AGENDA TULSA METROPOLITAN AREA PLANNING COMMISSION

Meeting No. 2721 May 4, 2016, 1:30 PM

PRELIMINARY SUBDIVISION PLAT

The Estates at the River II - (CD 8)
South of East 121st Street South, West of South Hudson Avenue

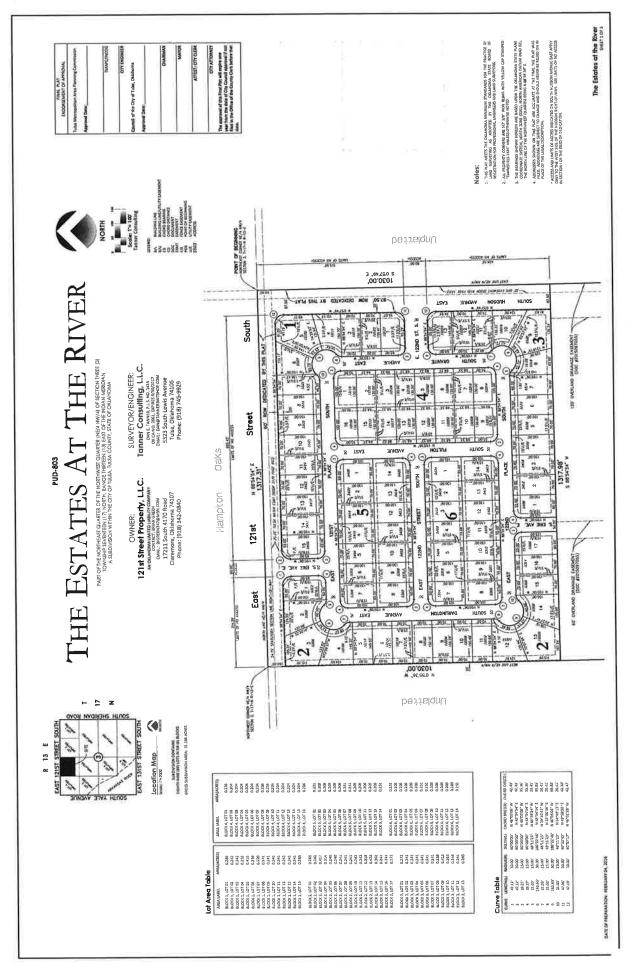
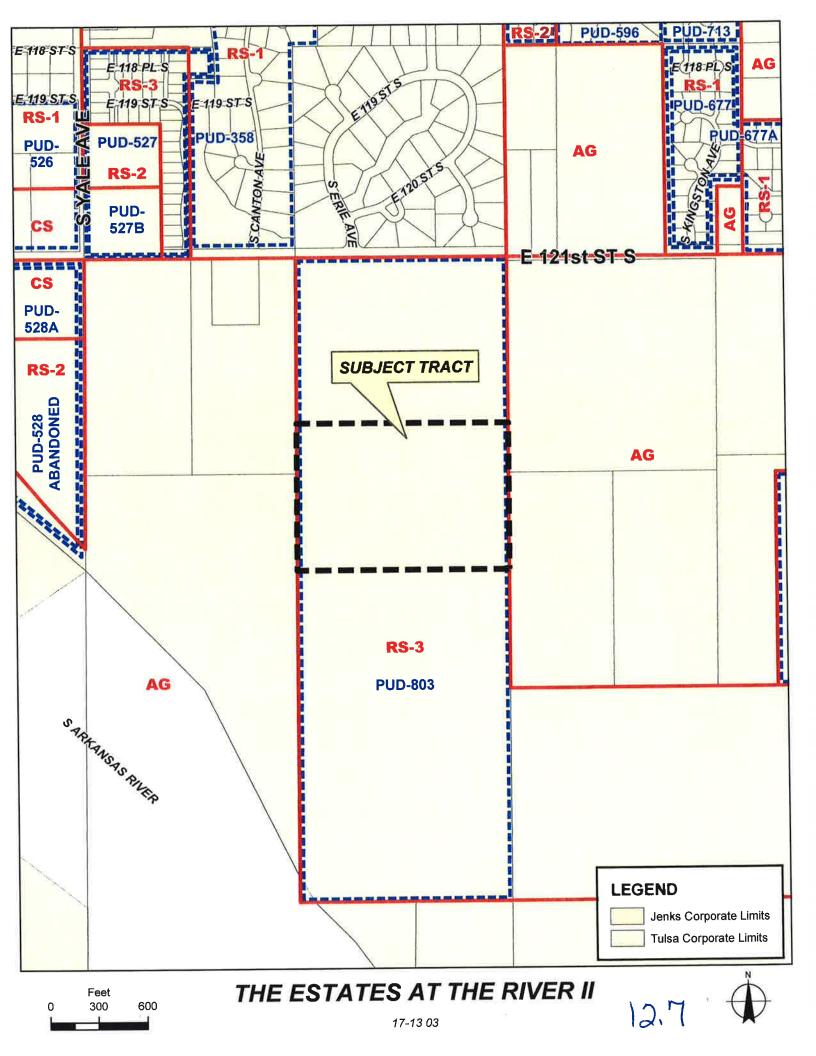
- **1. Zoning:** The property is zoned .Planned Unit Development 803.
- 2. Streets: Call out width of 123rd Street. Call out curve number on the face of the plat. Curve table has been provided without associated numbers shown on plan. An additional stub street should be considered to the west of the development. There is a concern about where a proposed possible bridge alignment may be positioned near the development and how traffic coming across the bridge will travel near the development and how Yale Avenue would be utilized with a new traffic pattern..

- 3. Sewer: A sanitary sewer easement, with a minimum width of 15 feet, with the sanitary sewer pipe centered within the easement, must be provided along the south line of Reserve A where the proposed sanitary sewer line crosses the Reserve.

- 4. Water: 1.10 Utility easement dedication requires Legal Department review for acceptance.
- 5. Storm Drainage: Floodplain Administrator: Historically, this parcel was inundated with floodwaters during the 1986 Arkansas River Flood. The proposed subdivision is almost entirely located within the City Regulatory and FEMA floodplains. The floodplain boundaries must be delineated on the plat as well as any necessary surface drainage easements or compensatory storage easements. Any proposed changes to the FEMA floodplain will require a CLOMR and LOMR (letters of map revision). All development shall be compliant with City of Tulsa Revised Ordinances Title 11 A.

- 6. Utilities: Telephone, Electric, Gas, Cable, Pipeline, Others: No comment.
- 7. Other: Fire: An approved turnaround will be required if Hudson is more than 150 feet dead ended from the center of 123rd Street. Fire hydrant coverage will be required per IFC 2015 Section 5-7.5 this includes Hudson Avenue.

- 8. Other: GIS: Provide individual lot addresses for the plat. Submit subdivision data control sheet with final plat. Incorporate the point of commencement along with the bearing and distance into the legal description up to the point of beginning. Remove the parcel lines and lot labels in the location map. Show only the platted subdivisions and label all other land as unplatted. Graphically show all property pins found or set on the face of the plat. Addresses: South Hudson Avenue East should really be South Granite

Place but it looks like The Estates at the River (which is just north of The Estates at the River II) has the street name as South Hudson Avenue. If The Estates at the River can change the street name to south Granite Place, then The Estates at the River II should also change the name to South Granite Place.

An IDP permit is required. All storm and sanitary easements require a 15 foot wide or 7.5 foot wide width on both sides of two lots. Indicate the width of 123rd Street. Use and Maintenance need to be clearly defined in the Deed of Dedication in plat covenants language for Section III E for Reserve A. Use City of Tulsa plat covenant language for Section 1.10, Utility easement dedication.
